**Merged Document Report****Application No.: PL9338**

Description :	
Address :	
Record Type :	PLAT

PLAT OF
ROYAL OAK SOUTH UNIT 3
A 25.087 ACRE TRACT OF LAND, MORE OR LESS, A PORTION OF BS & F
SURVEY 405, ABS. 567, NUECES COUNTY, TX
CORPUS CHRISTI, NUECES COUNTY, TEXAS

DATE PLOTTED: 7/3/26
CMP. NO. PLAT SH2
JOB NO.: 26021
SCALE: 1"= 50'
PLAT SCALE: SAME
SHEET 2 OF 3

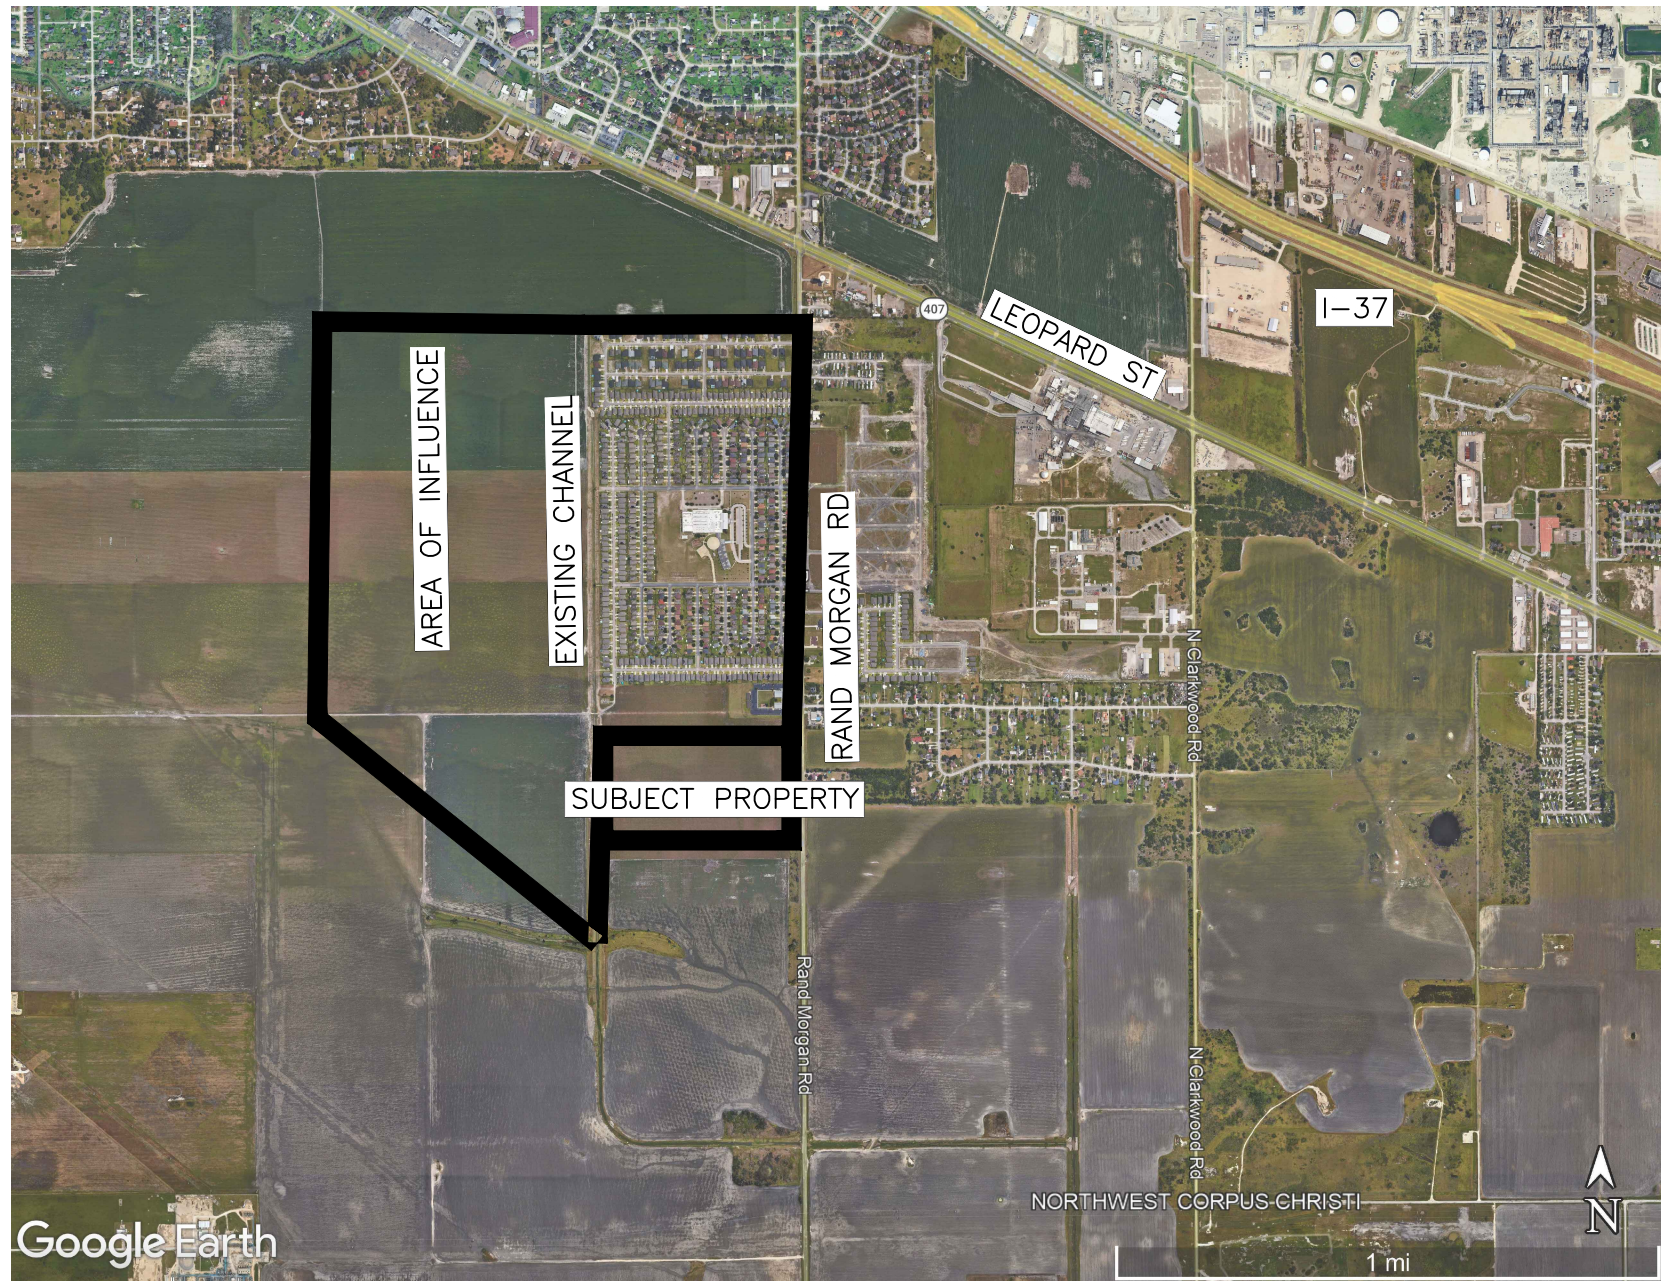
6	P001	Note	Mark Zans : LD	Closed	Change Michael Dice title to Interim Asst. City Manager	
7	P001	Note	Mark Zans : LD	Closed	Hatch the street dedication area and provide square footage of area.	
8	P001	Note	Mark Zans : LD	Closed	Comment page 2: Be aware that per UDC 8.4.2A that block lengths cannot exceed 1600 feet.	
9	P001	Note	Mark Zans : LD	Closed	Comment page 3: Be aware that per UDC 8.4.2A that block lengths cannot exceed 1600 feet..	
22	P001	Note	Mark Zans : LD	Closed	Stormwater comments #1: Per City of Corpus Christi - Code of Ordinances Ch. 14, Art.X, Sec. 14-1003, a Storm Water Quality Management Plan (SWQMP) is required. The following information is not included with the submittal: An on-site drainage plan, which details the direction of flow (using arrows or contours) and collection structures, including the size and required capacity of the drainage structures. -The on-site drainage plan should address how run-on storm water will be handled, including sheet flow entering the site from adjoining property. -Demonstrations of the conformance with existing master plan drainage and/or the need to master plan amendment for both on-site and off-site improvements. In the absence of a request

STORM WATER QUALITY ANALYSIS

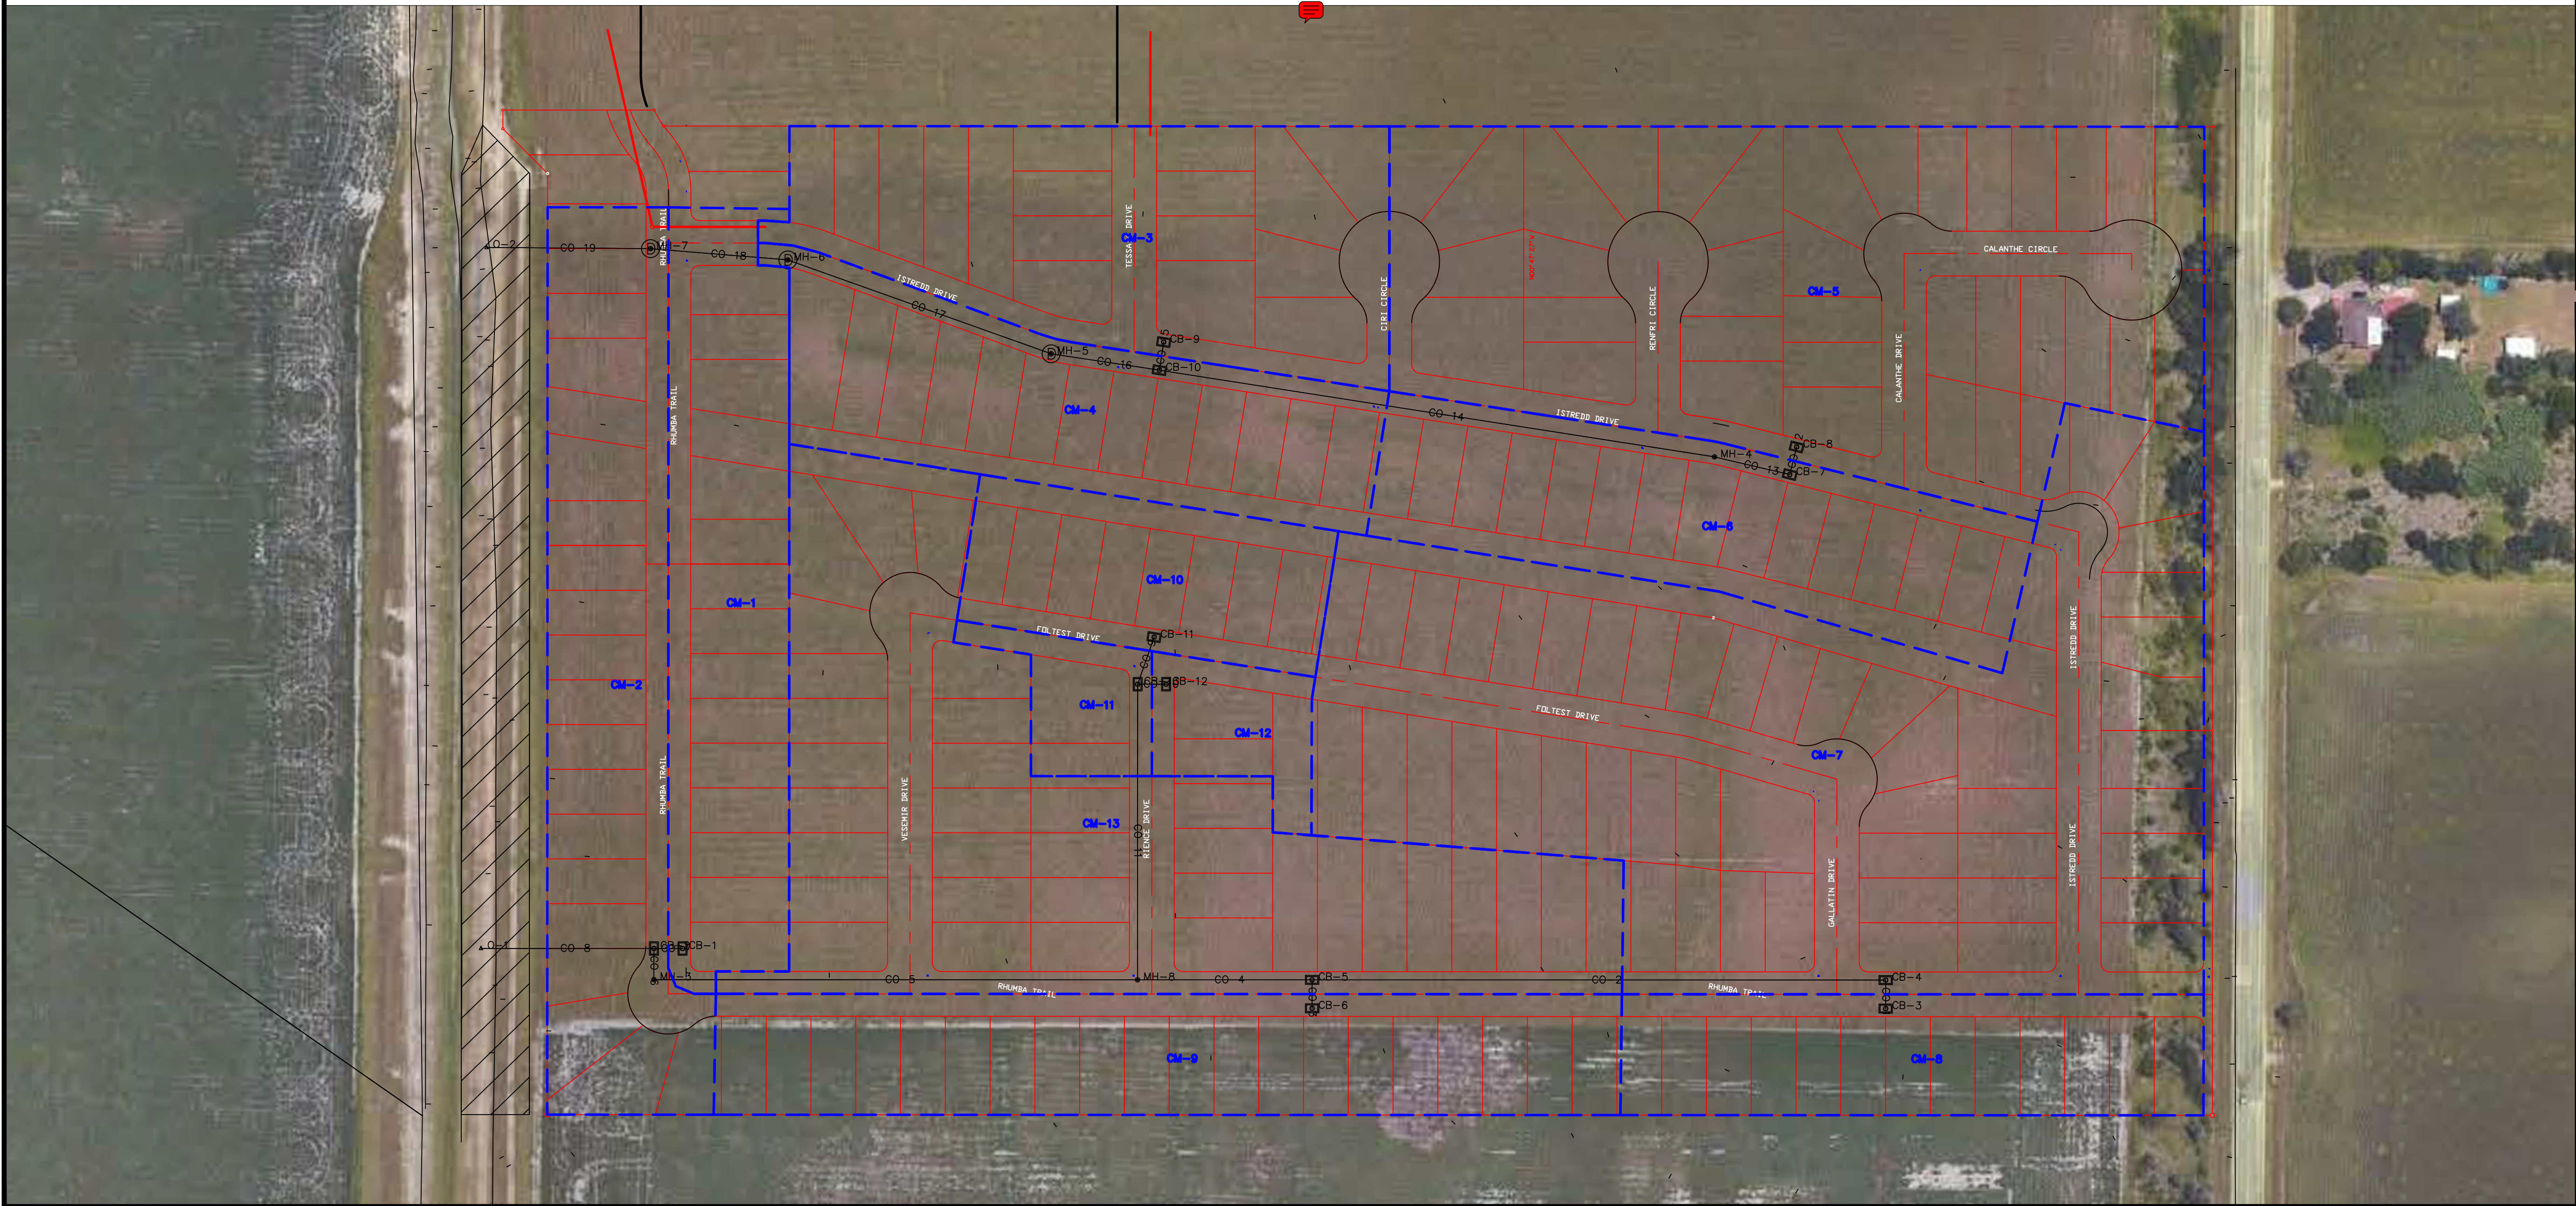
23	P001	Note	Mark Zans : LD	Closed	Stormwater comments #2: Storm Water Note #4 states: "MITIGATION OF STORAGE WILL OCCUR IN THE STREETS PRIOR TO BEING RELEASED TO THE DITCH." Comment: (Please confirm in PI phase) •The IDM dictates strict allowable flow depths during design storms (e.g., the 5-year storm must remain within the curbs, and the 100-year storm must not exceed the right-of-way lines or exceed a depth that threatens finished floor elevations). •Relying on street storage for mitigation requires a comprehensive 100-year ponding and street capacity analysis to verify that maximum depth limits are not breached, and emergency vehicle access is maintained Storm Water Note #5 states that the underground conduits will be phased and will "initially discharge into a temporary ditch that outfalls into the existing drainage channel." (1)Comment: (Please confirm in PI phase) •Provide dedicated construction details, cross-sections, and temporary drainage easements (TDE) for this interim ditch. •A phasing analysis must prove that intermediate phases will not overwhelm downstream segments before the final underground network is fully built out and tied into the ultimate channel. •Temporary erosion and sediment
